**REPLY TO BIDDER QUERIES**

Bid Doc No: 110330G/WGI/GAIL/03-R0

Project: Khera Compressor Station Upgradation Project

Item: Bid document for Terminal Works

**STANDARD  
FOR  
PIPE CULVERT FOR STORM  
WATER DRAINAGE**

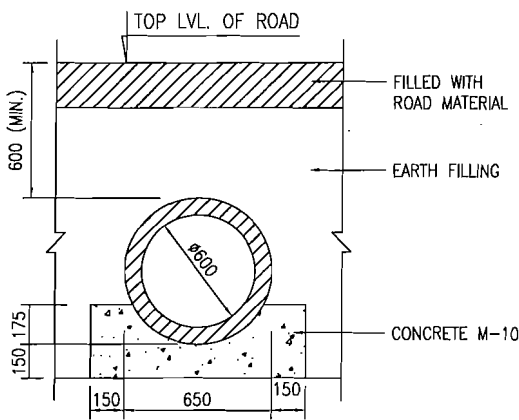
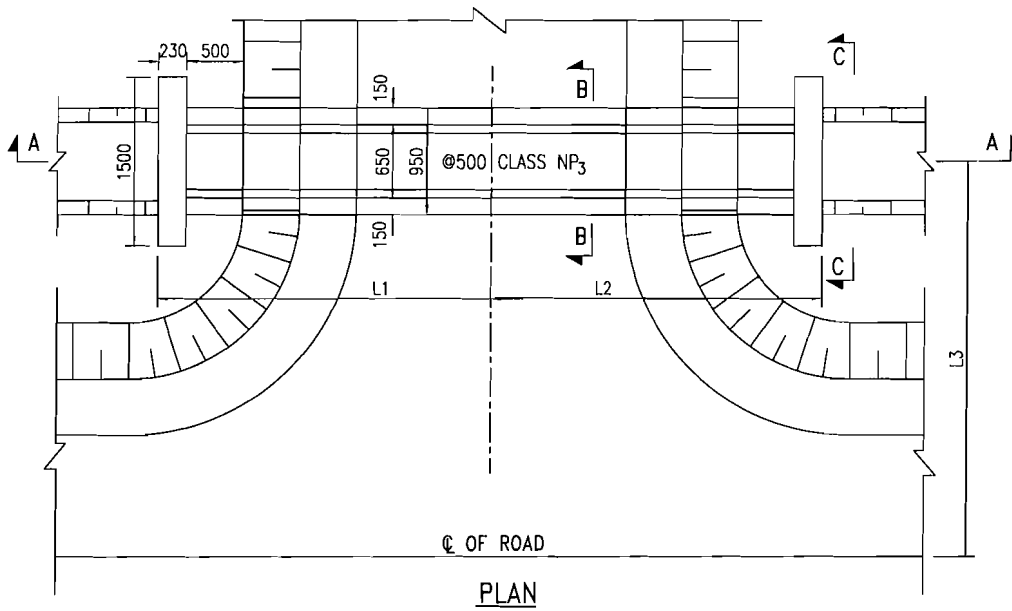
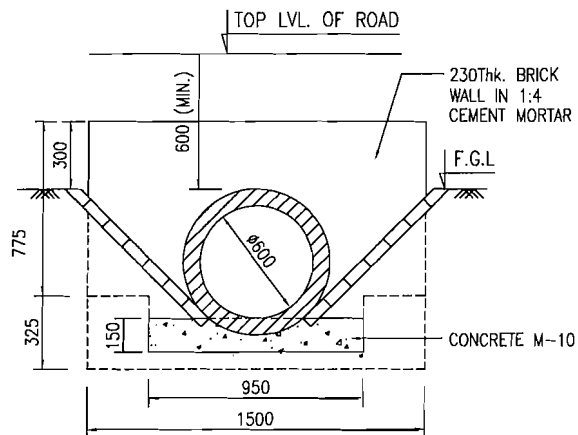
9	SINGH ENGINEERING WORKS	SOR Item No. B059: Drawing no. 1-05-041 is not available in the tender document? Hume pipe size mentioned in SOR item is 600 dia and as shown in Drawing is 1000 NB?	Size of hume pipe is 600 NB and reference drawing no. 1-05-041 is attached.
10	SINGH ENGINEERING WORKS	SOR Item No. C082: What is the Class of GI Pipe conduit?	Medium Class
11	SINGH ENGINEERING WORKS	Volume –II Technical: Page No.-11: Only 30" dia Valve & Filters to be supplied by owner, then what about 30" dia Pipes?	30"pipe, 30" valves and Filters are free issue material
12	SINGH ENGINEERING WORKS	Can Ultrasonic Testing be done after completion of all welding work or is it to be done before welding?	UT is to be done after welding.
13	SINGH ENGINEERING WORKS	As mentioned on page 12 of 345 of Volume –II Technical: The locations from where 30" dia pipes are to be shifted is Usar, Budrak, Mumbai, Hazira?	30" Line pipes are lying at Khera Site. Handling, stacking, storing, shifting of pipes to Khera terminal site is under contractor scope.
